**FINDINGS AND RECOMMENDATION  
OFFICE OF PLANNING AND ZONING  
ANNE ARUNDEL COUNTY, MARYLAND**

**CASE NUMBER:** 2025-0040-V

The applicants are requesting a variance to allow a new dwelling and an accessory structure (pool) with less setbacks and buffer than required, disturbance to slopes of 15% or greater, and the new dwelling that does not comply with the designated location of a principal structure on a waterfront lot on property located at 1836 Cove Point Road in Annapolis.

VARIANCE PLAN  
**1836 COVE POINT ROAD**  
1836 COVE POINT ROAD, ANNAPOLIS, MD 21401  
TAX ACT. NO. 02-000-02456700  
TAX MAP 045F GRID 0002 PARCEL 0540 DISTRICT 2ND  
ANNE ARUNDEL COUNTY, MARYLAND

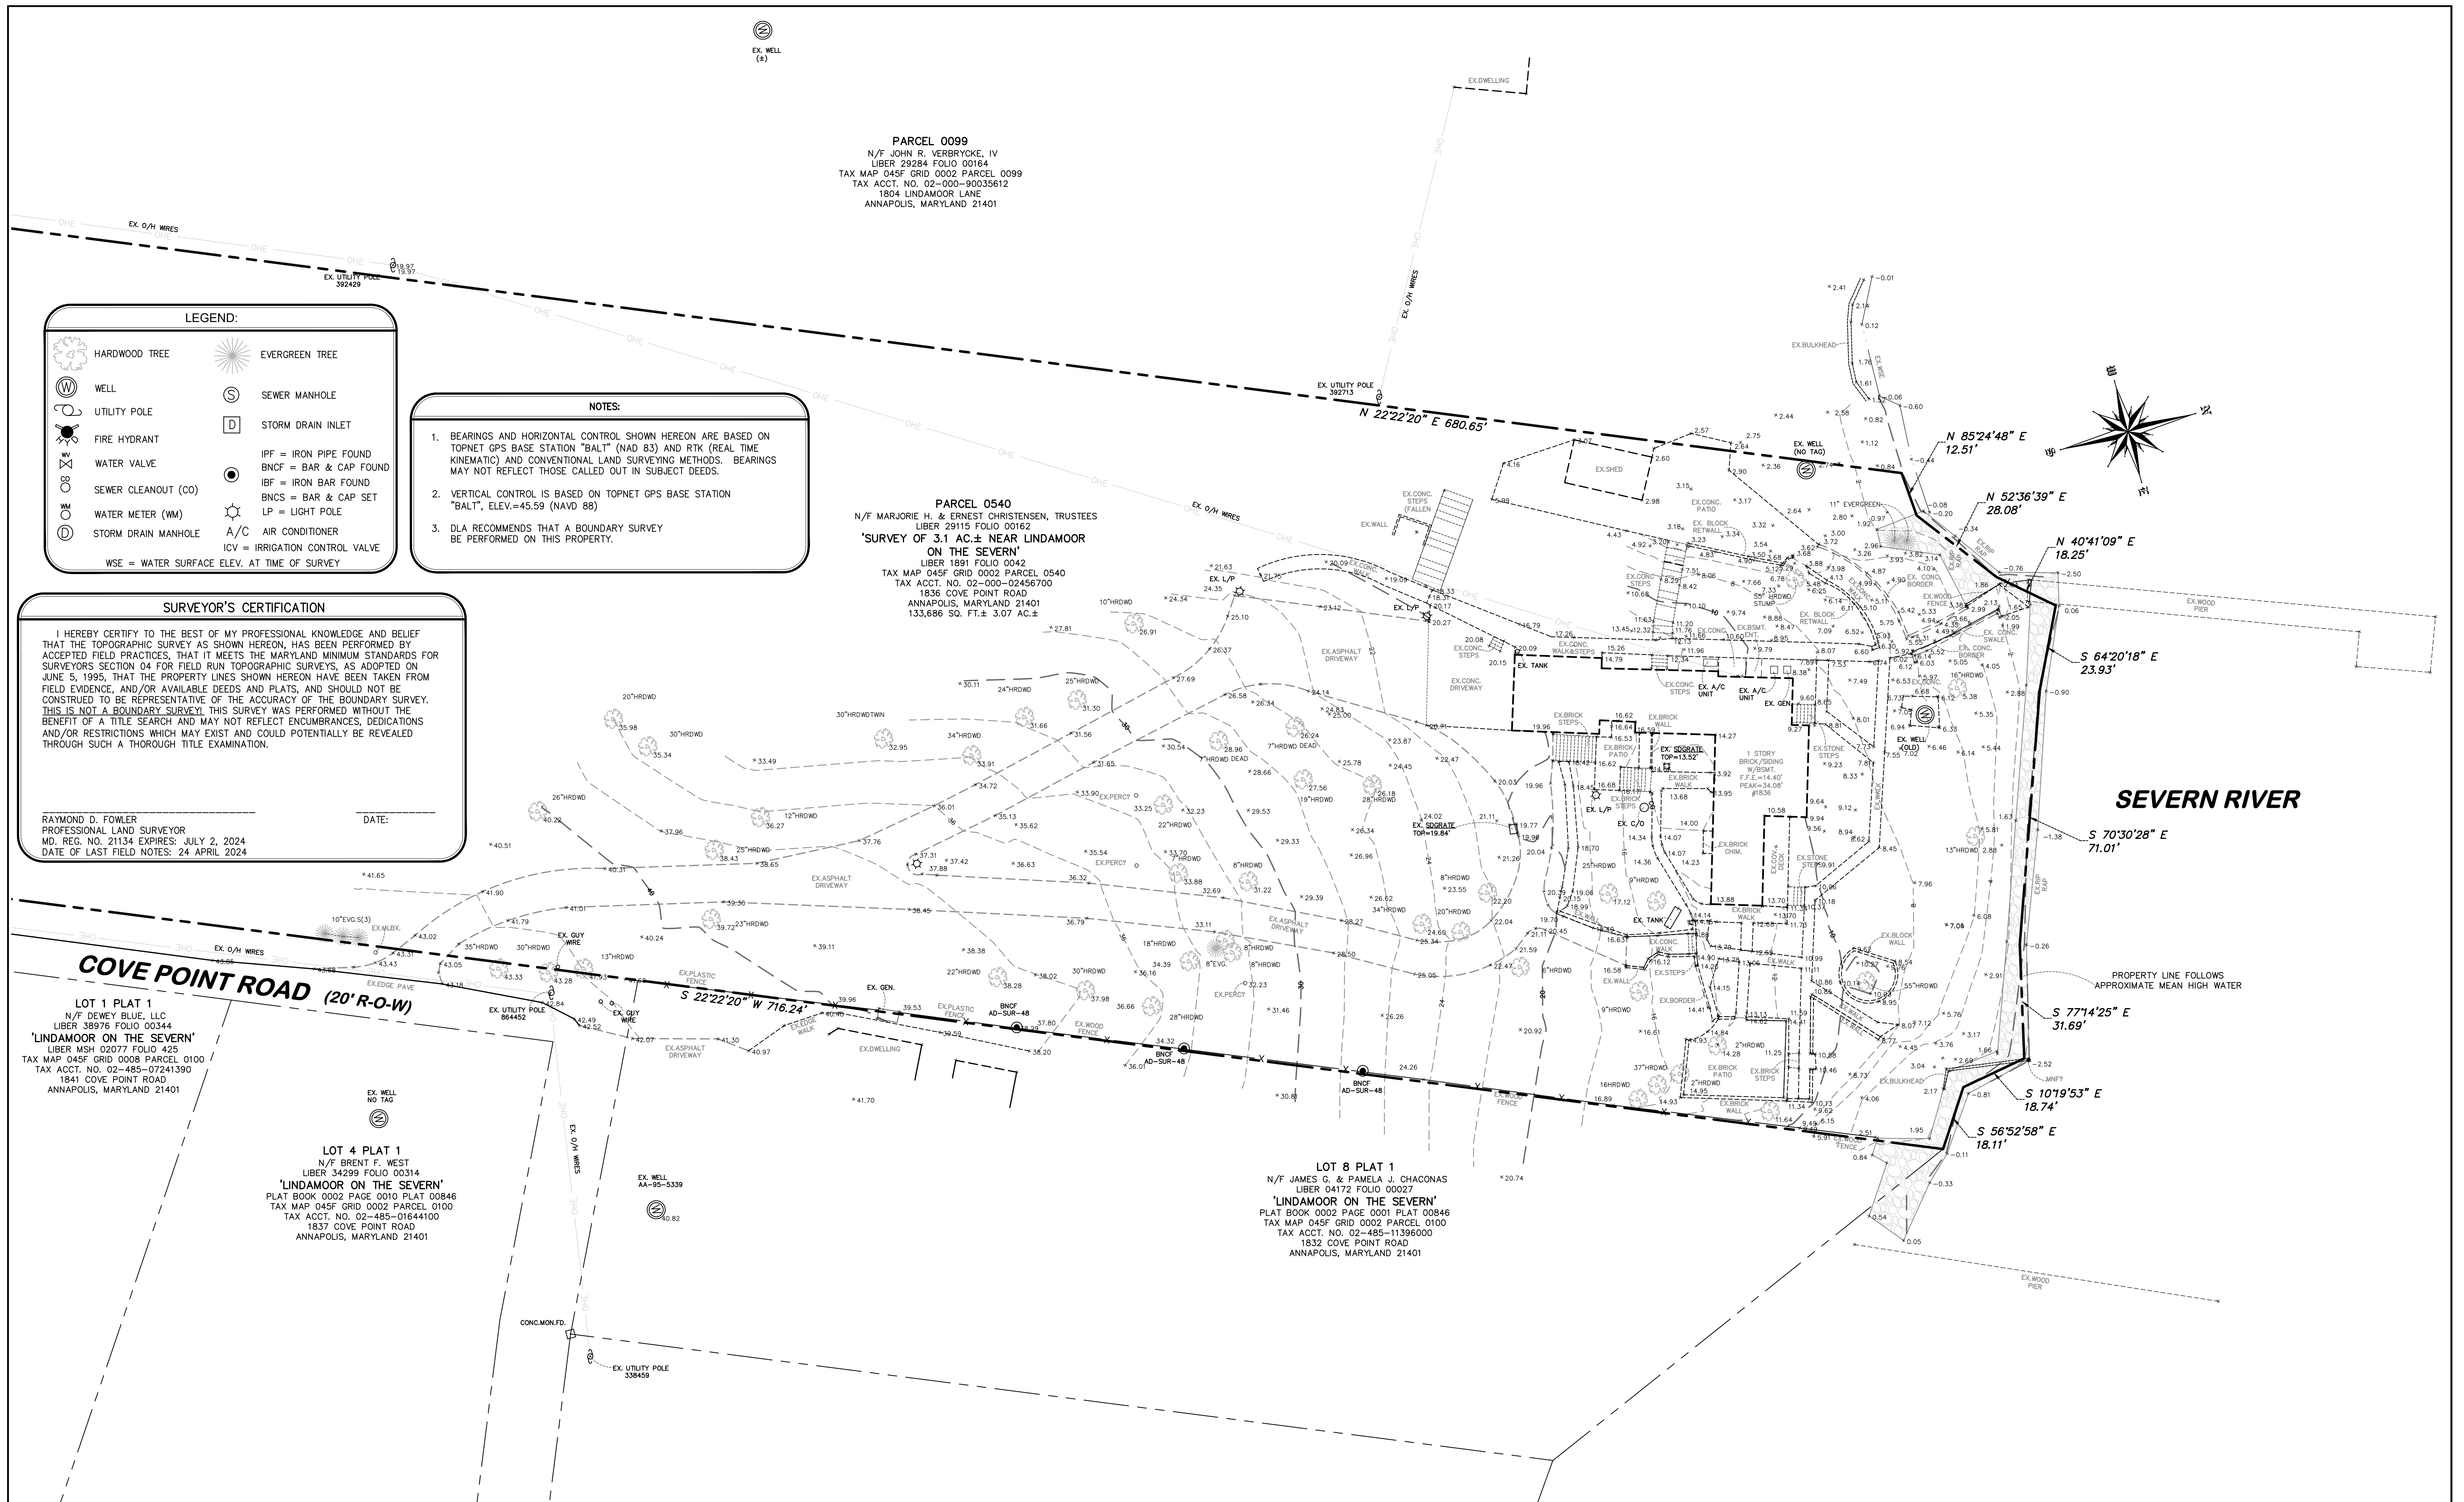
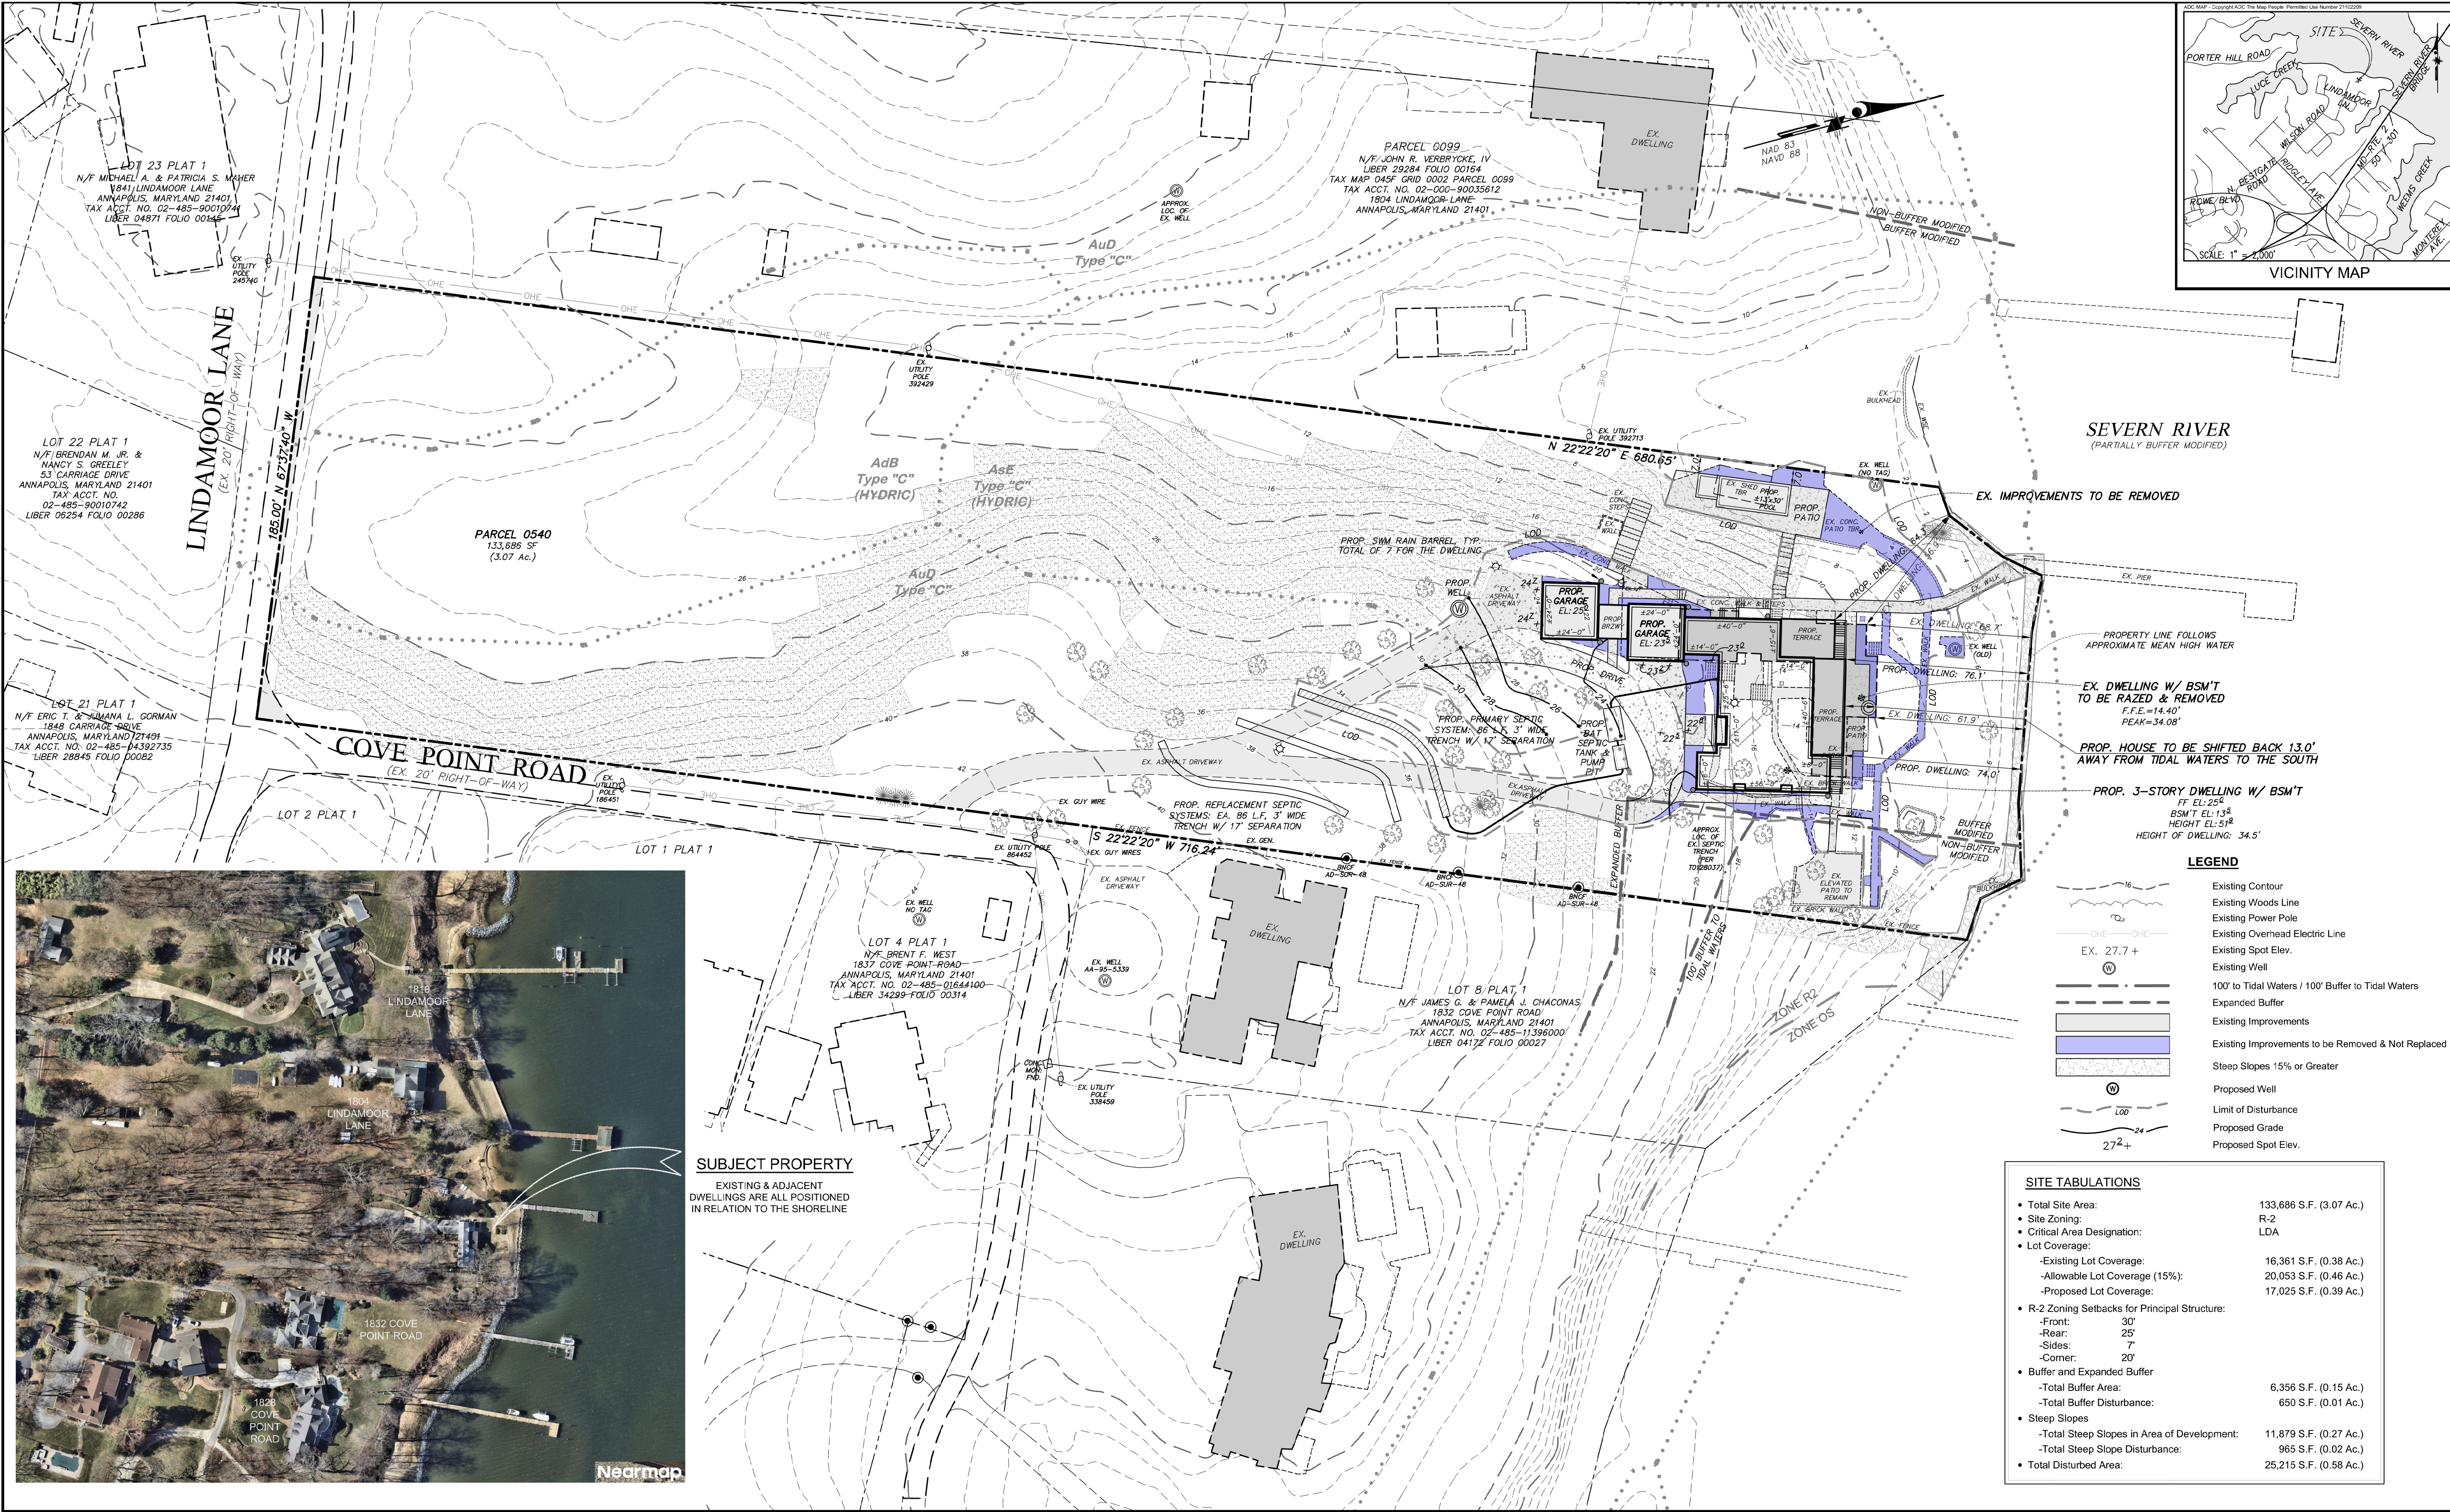
This Office has no objection to the location of the pool/patio provided the applicant can demonstrate that there will be no additional slope disturbance related to the location. The site plan is not clear since the symbols used for steep slopes and paving are very similar.

- 2. It is acknowledged that a combined existing and proposed conditions Variance Plan was submitted. However, for clarity, please submit an existing conditions Variance Plan and a separate proposed conditions Variance Plan.

- 3. On the Site Plan, show the Limit of Disturbance (LOD). Additionally, although it is stated on the Critical Area Project Notification Sheet, on the Site Tabulations table on the Site Plan, state the Total Disturbed Area.

- 4. It does not appear the entirety of the steep slopes are shown on the Site Plan. On the Site Plan, show all of the steep slopes on and off the site.

- 5. On the Site Plan, show the rain barrel locations and their sizes and identify where the rainwater collected in these barrels will be discharged.
- 6. Label the bold lines going through the proposed primary septic system field. If these are proposed contours, label them accordingly and include this symbol in the legend.
